Appendix E - Part 2

Agency Correspondence

Meeting Date: September 6, 2022 **Project No.:** 300052314.0000
Project Name : Warden Avenue and Kennedy Road Environmental Assessment Studies
Meeting Subject: Discussion of Preferred Road Cross-Section with City of Markham
Meeting Location: Microsoft Teams Meeting
Date Prepared: September 16, 2022

Possible Examples for Separated Sidewalk and Cycle Track

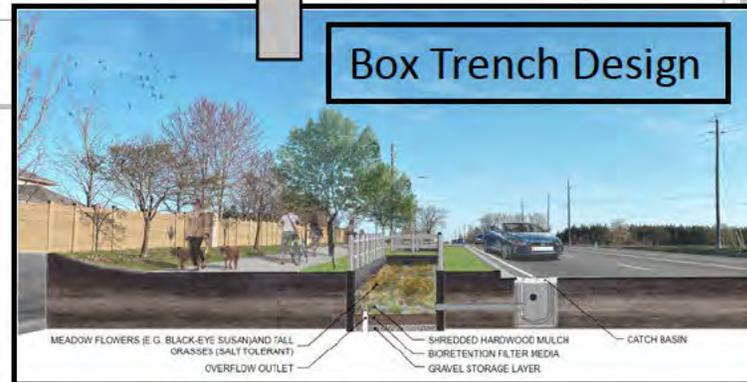
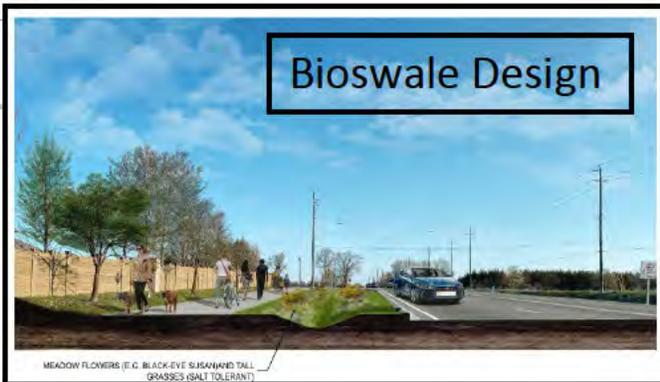
006	Evaluation Matrix	Urban Design	X-section	<ul style="list-style-type: none"> Please clarify the purpose of a 0.5 limited marked median proposed for Alternative Design Concept 3. Staff suggest a raised median with shrubs in the center of the road similar to what has been illustrated in Design Concept 1, if possible. The width of the raised median can be reduced if needed. Please refer to the sketch attached. 	
007	Evaluation Matrix	Urban Design	X-section	<ul style="list-style-type: none"> Street tree planting should be maximized along the corridor where feasible. Consider planting double row of trees in key locations, where possible. 	
008	Evaluation Matrix	Urban Design	X-section	<ul style="list-style-type: none"> Please consider introducing street furniture such as seating elements and trash receptacles. 	
009	Evaluation Matrix	Urban Design	X-section	<ul style="list-style-type: none"> Staff recommend separating the boulevard sidewalk and MUP to minimize conflicts and enhance a retail supportive corridor. LID features can be moved closer to the curb which allows more room to accommodate a sidewalk. Please refer to the sketch attached.

Preferred Design Concept - Warden Avenue - Plan View

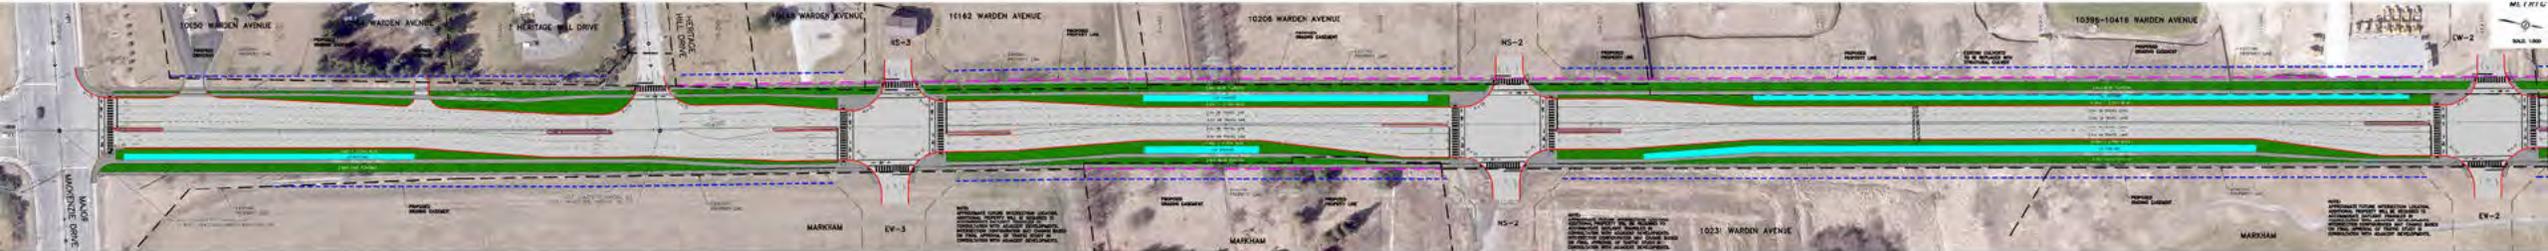
015	PIC #2	Urban Design	LID features	Refer to the mark-up drawings attached to the email for additional comments	
016	PIC #2	Urban Design	City track markings	Provide pavement markings for the cycle track to indicate the bike travel directions.	
017	PIC #2	Urban Design	Street Furniture	Consider introducing street furniture (e.g., benches, bike racks, and trash receptacles) to the corridors, particularly at retail-focused intersections and neighborhood service nodes as identified by the FUA Conceptual Master Plan Community Structure Plan.

015	PIC #2	Urban Design	LID features	Refer to the mark-up drawings attached to the email for additional comments	
a				Consider revising the section or provide a new one to show bioswale design in relation to other proposed street elements. Introduce trees to the boulevard areas that are closer to the curbline.	Based on the stormwater management plans, all the LID features in the Warden Avenue corridor are box trenches. As such, the study team does not intend to prepare a new concept / section to illustrate the bioswale design. York Region requires a minimum width of 3.4m for tree planting behind the curb. Based on the preferred design concept cross-section, the boulevard area closer to the curb (softscape) is 2.7 m wide, which is less than the Region's minimum standard for tree planting. Spacing for tree planting is therefore limited presently to the 3.5 m planted boulevard area between the sidewalk and cycle track. During the detailed design phase of the project, the softscape width will be further reviewed to confirm if additional tree planting can be achieved.
